## SERVICE LETTER 00100

<b>Date Released:</b>	June 17, 2024
<b>Date Effective:</b>	June 17, 2024
<b>Subject:</b>	RV-14 Fuselage Laser-Cut Parts Remediation
<b>Affected Models:</b>	RV-14 fuselages constructed with a laser-cut F-01405A  RV-14A fuselages constructed with a laser-cut F-01405A, and/or F-01451-L/R, and/or F-01448A and/or F-01448C-L/R
<b>Required Action:</b>	Inspect the aforementioned parts for fatigue cracks propagated from fastener holes. In many places, cracks will not be visible until they have propagated beyond the flanges of overlapping parts. If cracks are present, replace the laser-cut parts with a punched part. If cracks are not present, install the alternate fix detailed below.
<b>Time of Compliance:</b>	Inspect within 200 flight hours or at the next annual inspection, whichever is earlier.  If fatigue cracking is not present, you may continue to comply with this Service Letter via ongoing inspection no less than every 12 months or 200 flight hours, whichever is first.  Upon or before reaching 1000 flight hours, the alternate fixes must be conducted as outlined in this Service Letter, at which point compliance has been met without need for ongoing inspection.

**FIGURE 1:** F-01405A ALTERNATE FIX OVERVIEW

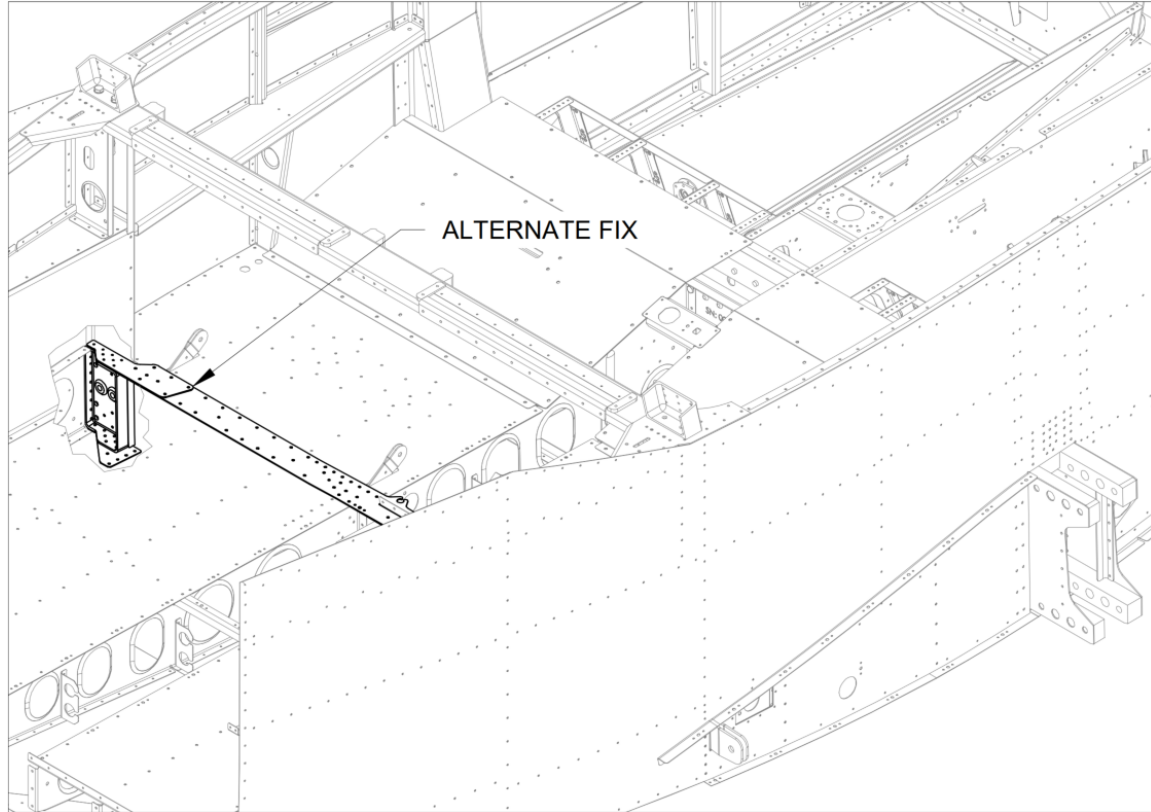
In the RV-14 and RV-14A, the F-01405 Bulkhead Assembly is a highly-loaded section of the fuselage structure built upon the F-01405A Bulkhead Bottom Channel; classified as Recommended for Replacement. Replacement of the F-01405A would be very involved on a flying aircraft, a QuickBuild Kit, or a Standard Kit that has progressed past Section 25 of the KAI (Kit Assembly Instruction). However, an alternate fix has been developed, restoring the structure to as-good or better structural strength and durability in service, with a drastically reduced workload. Installation of the alternate fix is outlined in Section 1 of this Service Letter, with an overview shown in Figure 1.

**FIGURE 2: REMOVING SIDE SKIN AND BOTTOM SKIN RIVETS (VIEWED FROM BEHIND AND BELOW REAR SPAR ATTACH)**

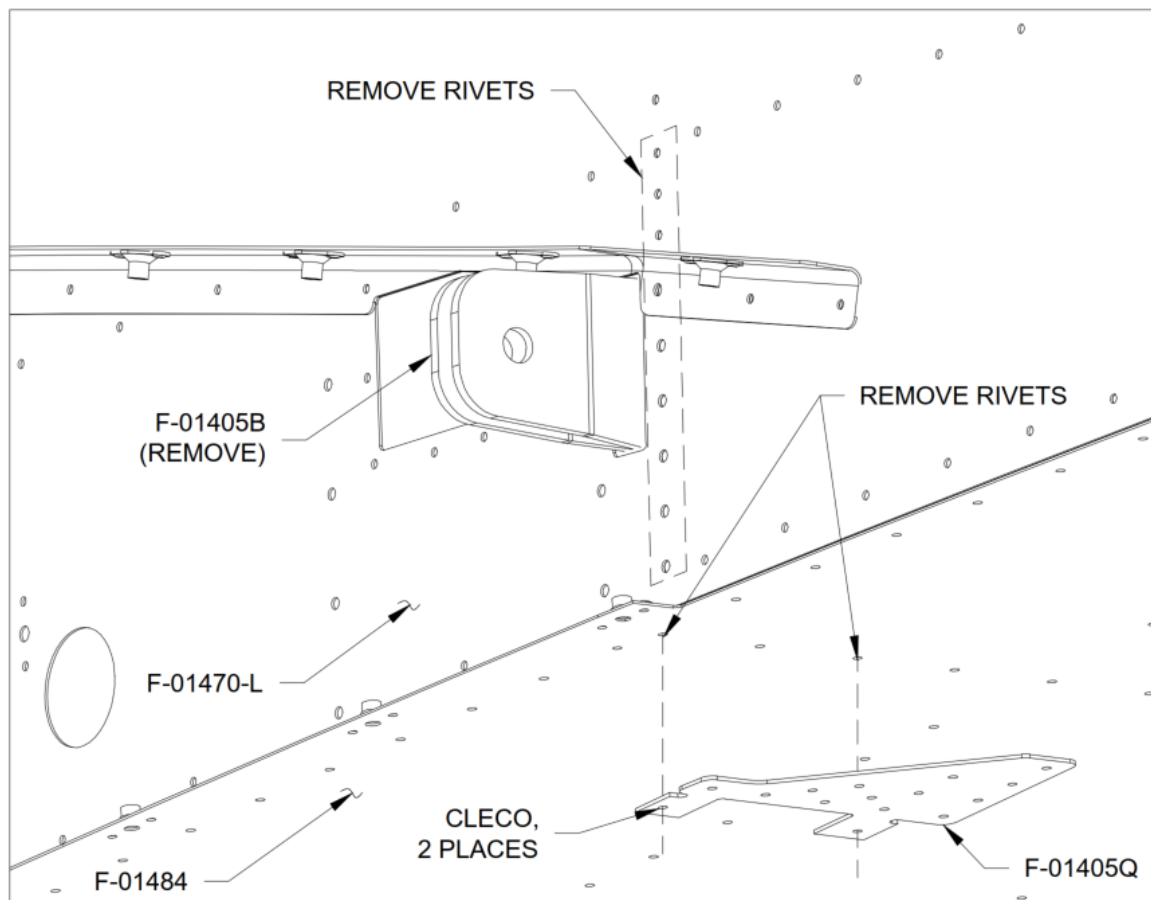
Step 11: Remove the F-01405B Bulkhead Bar as called out in Figure 2.

Step 12: Remove the rivets common with the F-01470-L Fuselage Side Skin and underlying structure as called out in Figure 2.

Step 13: Remove the two rivets in the F-01484 Center Bottom Skin, which are common with the F-01405A, as called out in Figure 2. See Figure 3 for additional clarity.

Step 14: Dimple the two locating holes in the F-01405Q Doubler, then cleco to the F-01484. Reference Figure 2.

**FIGURE 3:** MATCH-DRILLING BOTTOM SKIN  
(VIEWED FROM THE BOTTOM OF THE FUSELAGE)

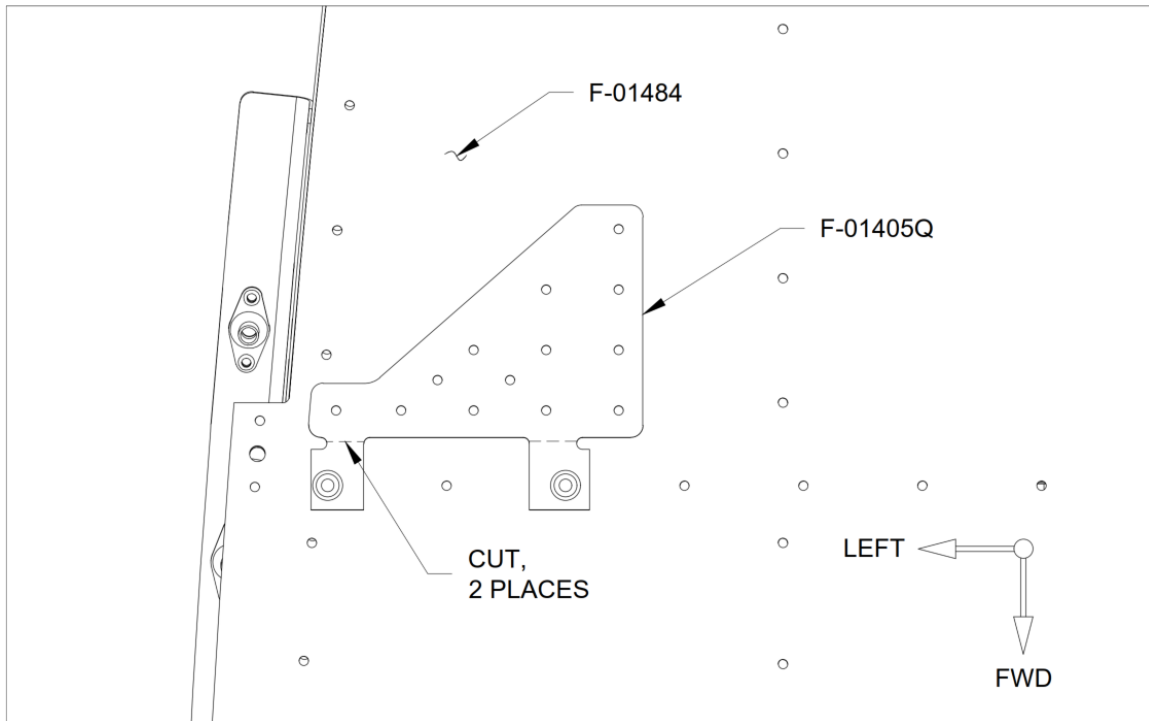
Step 15: Match-Drill #40 the 13 holes in the F-01405Q into the F-01484. See Figure 3.

Step 16: Remove the F-01405Q and cut the locating tabs off as called out in Figure 3.

**FIGURE 4: REMOVING BULKHEAD RIVETS  
(SOME PARTS NOT SHOWN FOR CLARITY)**

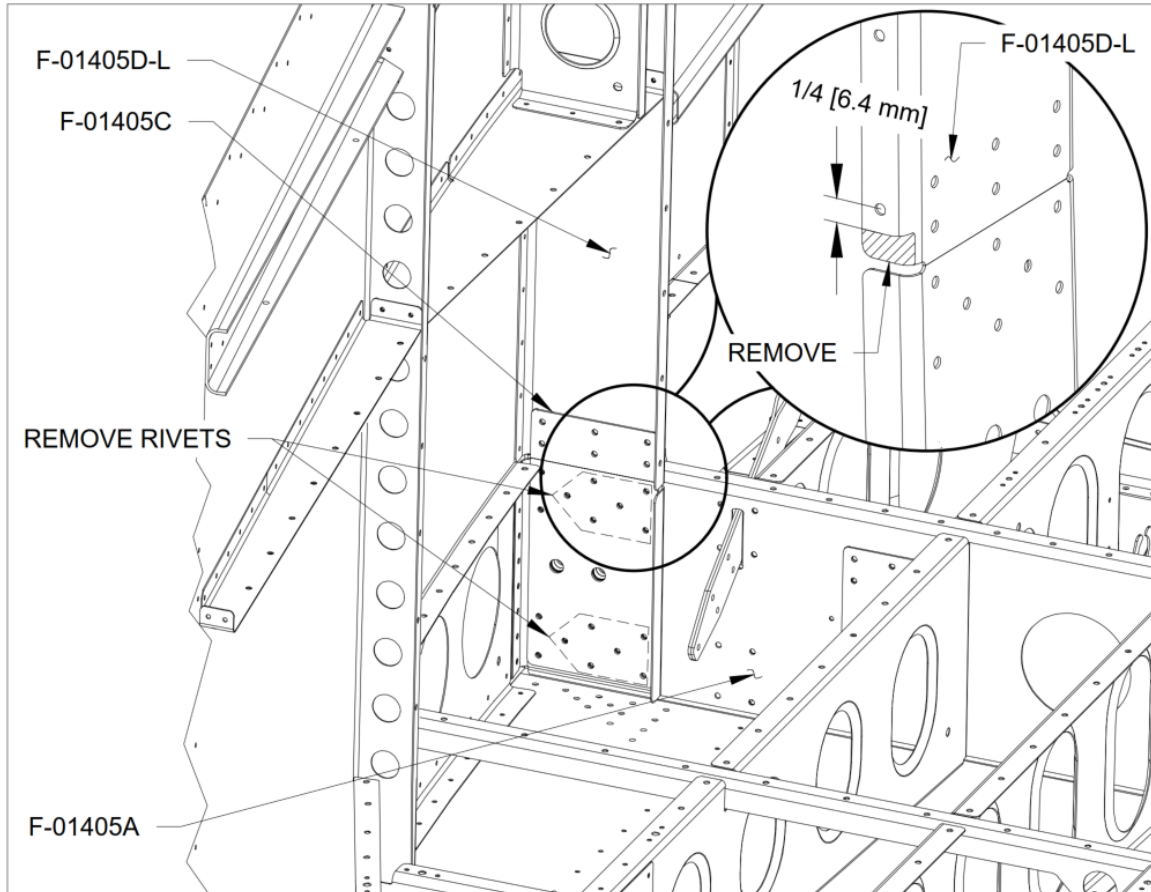
Step 18: Remove the rivets common to the F-01405A, F-01405D-L Bulkhead Side Chanel, and F-01405C Bulkhead Doubler as called out in Figure 4.

Step 19: Remove the hatched area of the F-01405D-L as called out in the detail view of Figure 4.

**FIGURE 5: LUG FITTING PREP**

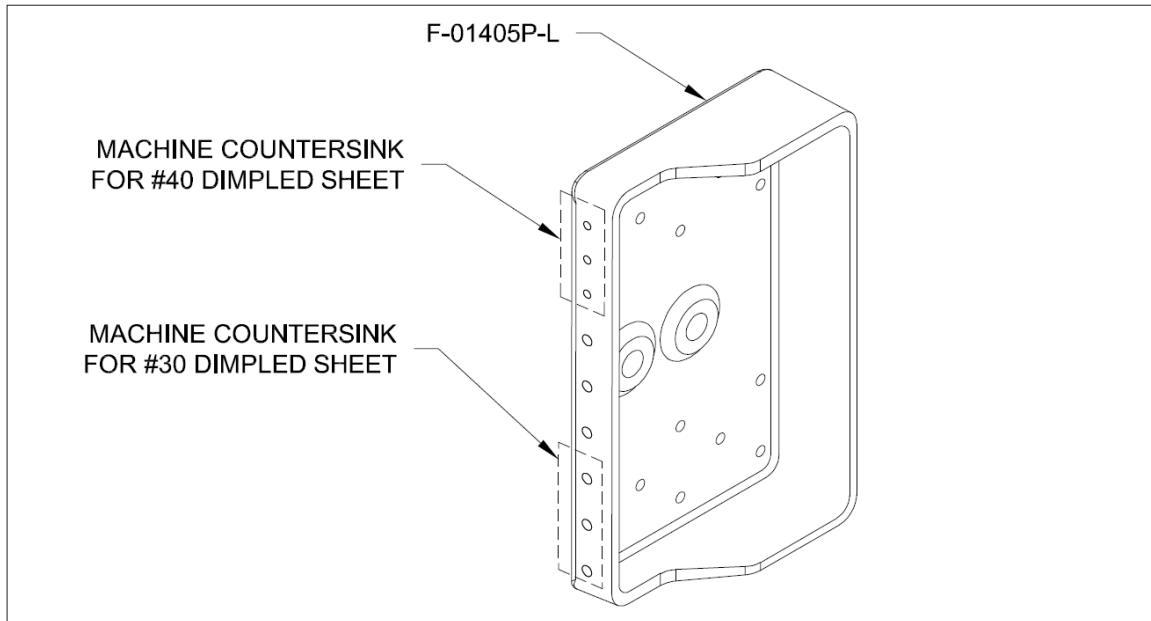
**Step 20:** Machine countersink the holes in the flange of the F-01405P-L Lug Fitting as called out in Figure 5.

**FIGURE 6: MARKING THE F-01447-L**

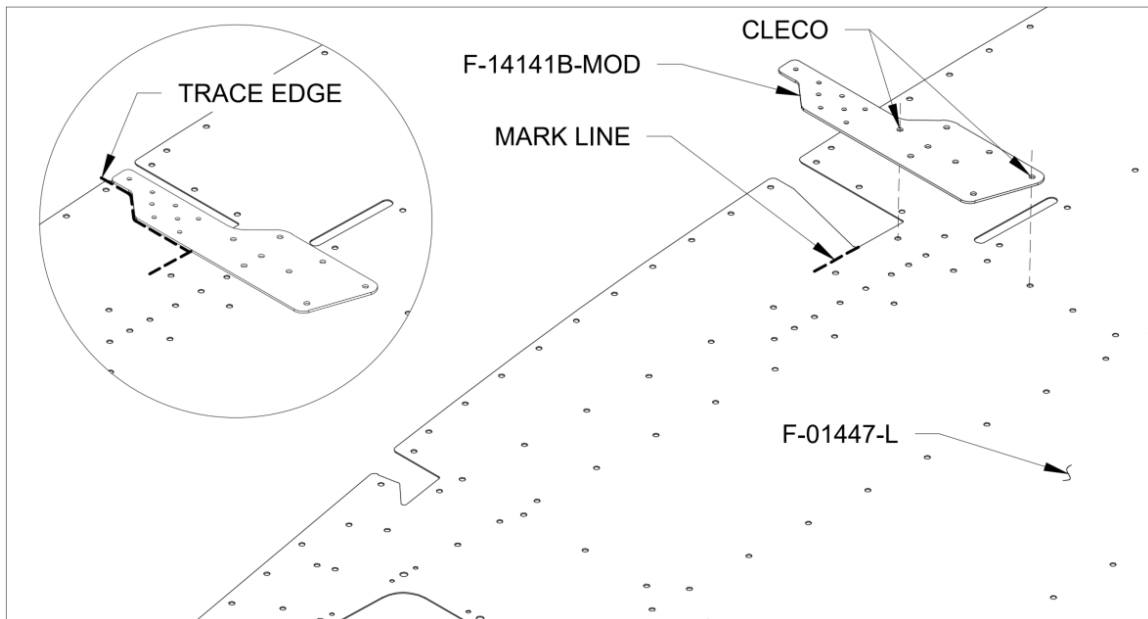
**Step 21:** Mark a line on the F-01447-L Baggage Floor collinear with the inside edge of the notch. See Figure 6.

**Step 22:** Cleco the F-14141B-MOD Doubler to the F-01447-L. See Figure 6.

**Step 23:** Trace the edge of the F-14141B-MOD from the line previously marked, to the outboard edge of the F-01447-L. See the detail view of Figure 6.

**FIGURE 7:** TRIMMING THE F-01447-L

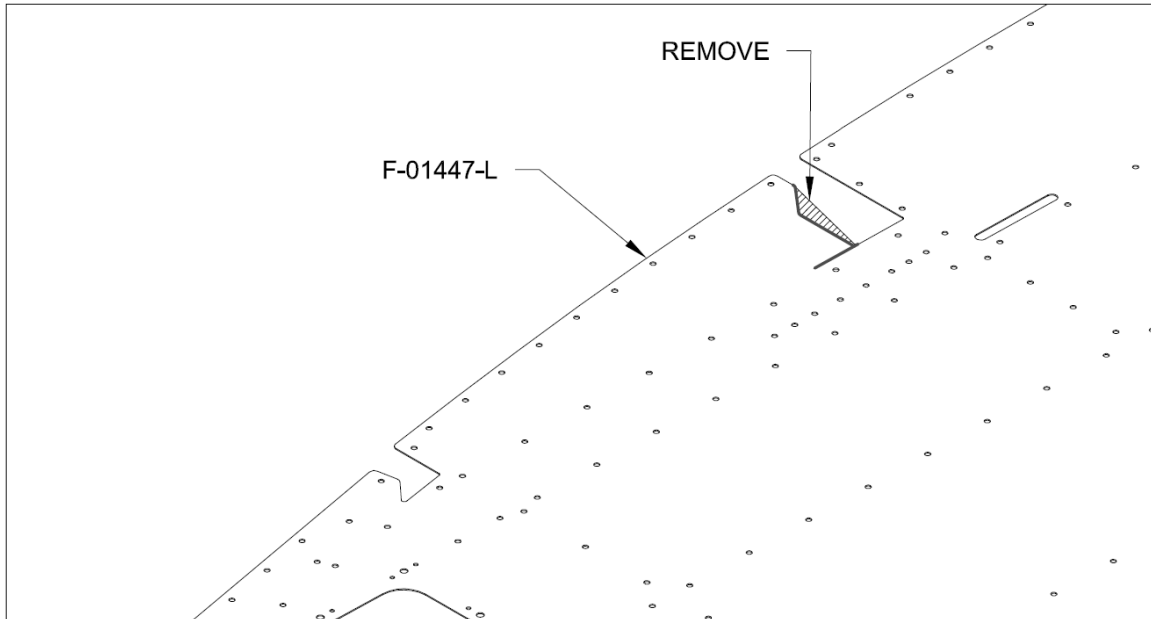
Trim away the hatched area of the F-01447-L as shown in Figure 7 (within the boundary of traced and marked lines).

**FIGURE 8:** DRILLING THE F-01405P-L  
(SOME PARTS NOT SHOWN FOR CLARITY)

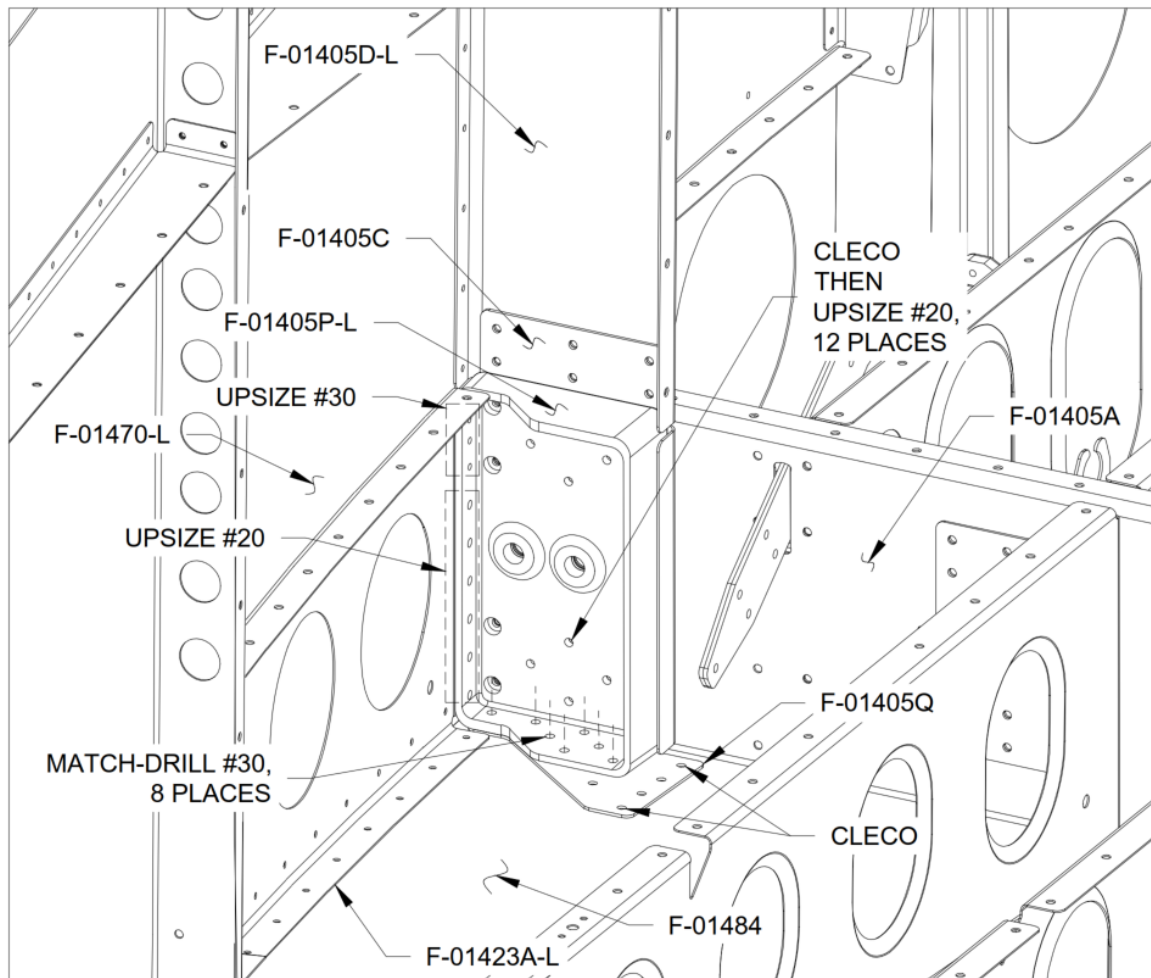
Step 25: Cleco the F-01405Q-L to the F-01484, this time inside the fuselage. See Figure 8.

Step 27: Upsize the 12 holes in the web of the F-01405P-L into the F-01405C, F-01405D-L, and F-01405A. See Figure 8.

Step 28: Upsize the holes common to the outboard flange of the F-01405P-L and the F-01470-L, F-01423A-L Outbd Baggage Rib, and F-01405D-L. See Figure 8.

Step 29: Match-Drill the eight holes from the F-01484 and F-01405Q-L into the bottom flange of the F-01405P-L. See Figure 8.

**FIGURE 9:** RIVETING THE F-01405P-L  
(SOME PARTS NOT SHOWN FOR CLARITY)

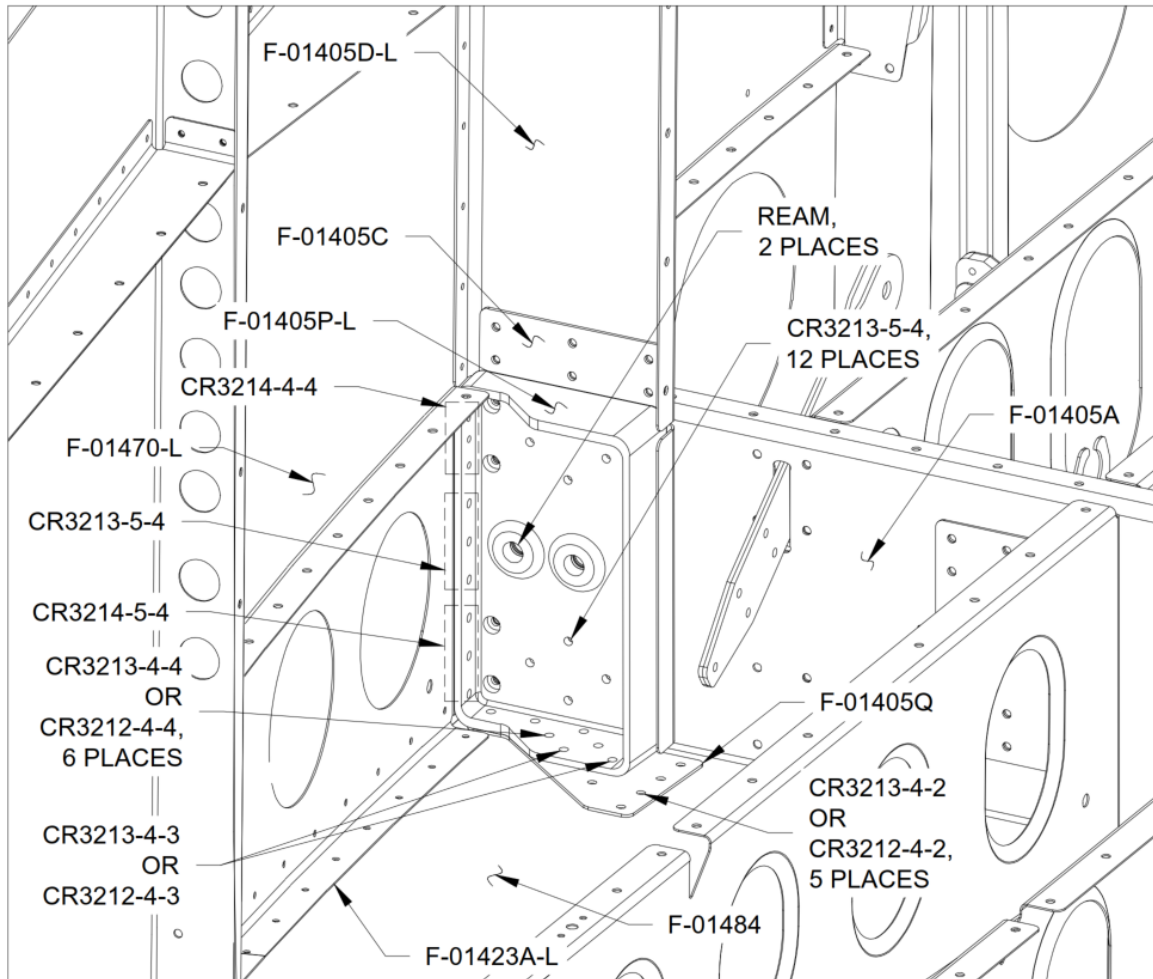
Step 33: Rivet the F-01405P-L and F-01405Q to the surrounding structure as called out in Figure 9.

**FIGURE 10: FITTING THE F-14141B-MOD AND F-14141A-MOD**

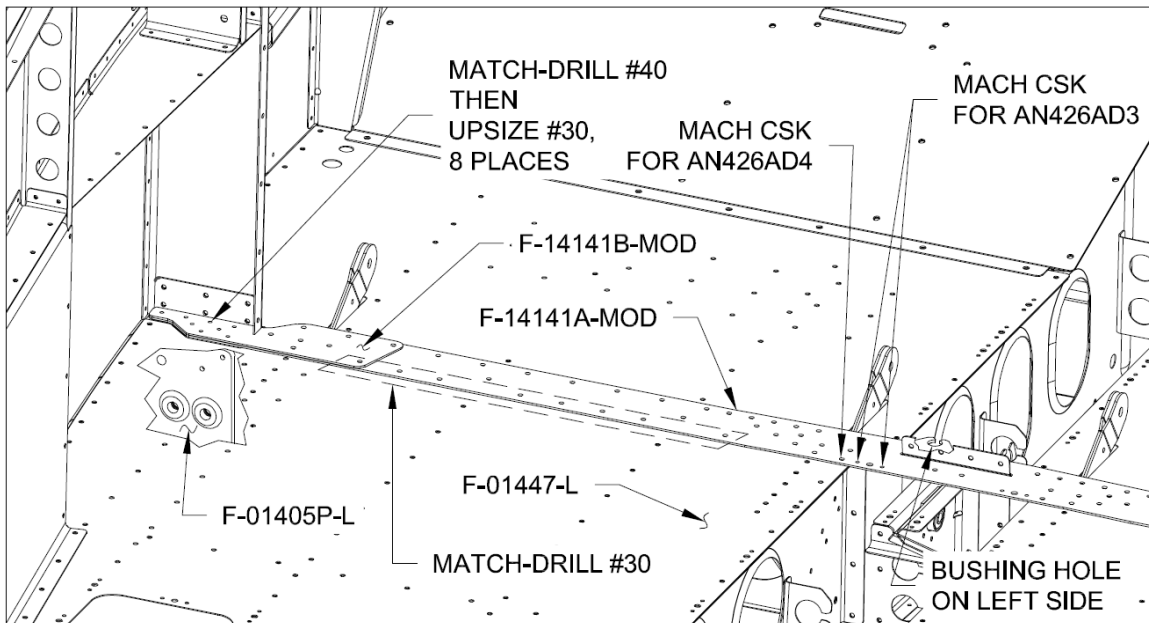
Step 36: Cleco the F-14141A-MOD Baggage Floor Splice and F-14141B-MOD into the position shown in Figure 10. Note that the bushing hole is located on the left side as shown.

Step 38: Match-Drill #30 the indicated holes from the F-14141B-MOD and/or the F-14141A-MOD into the F-01447-L as called out in Figure 10.

Step 39: Machine countersink the the three holes in the F-14141A-MOD as called out in Figure 10.

**FIGURE 11:** RIVETING THE F-14141B-MOD AND F-14141A-MOD

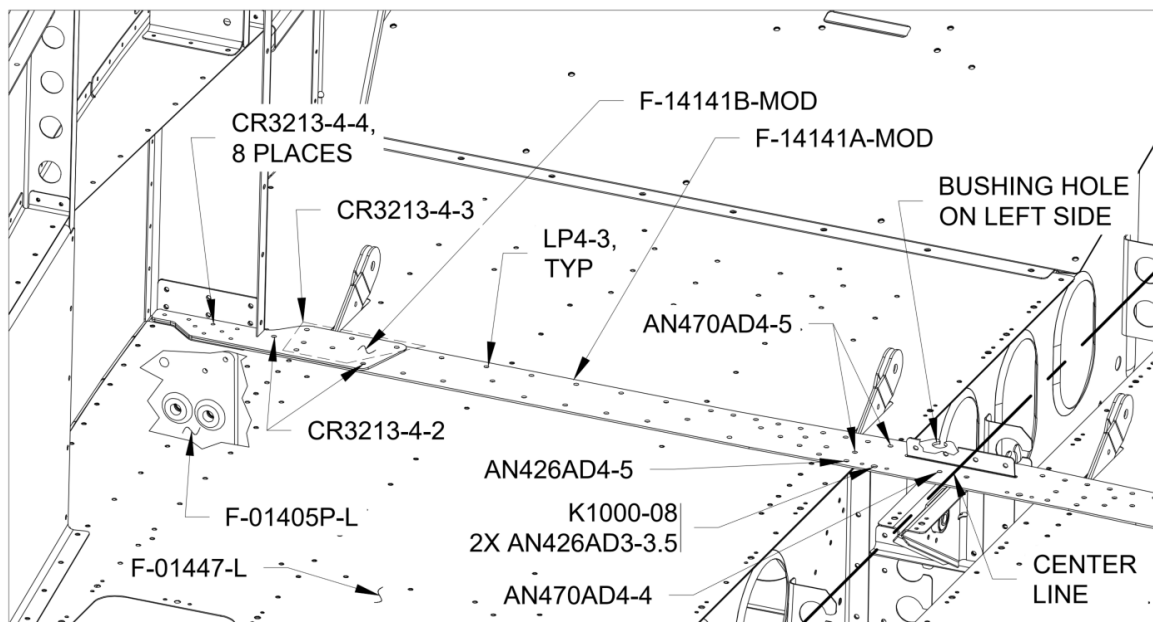
Step 42: Cleco the F-01447-L, F-14141A-MOD and F-14141B-MOD into position. Reference Figure 11.

Step 44: Rivet the the F-14141A-MOD and F-14141B-MOD to the underlying structure. See Figure 11.
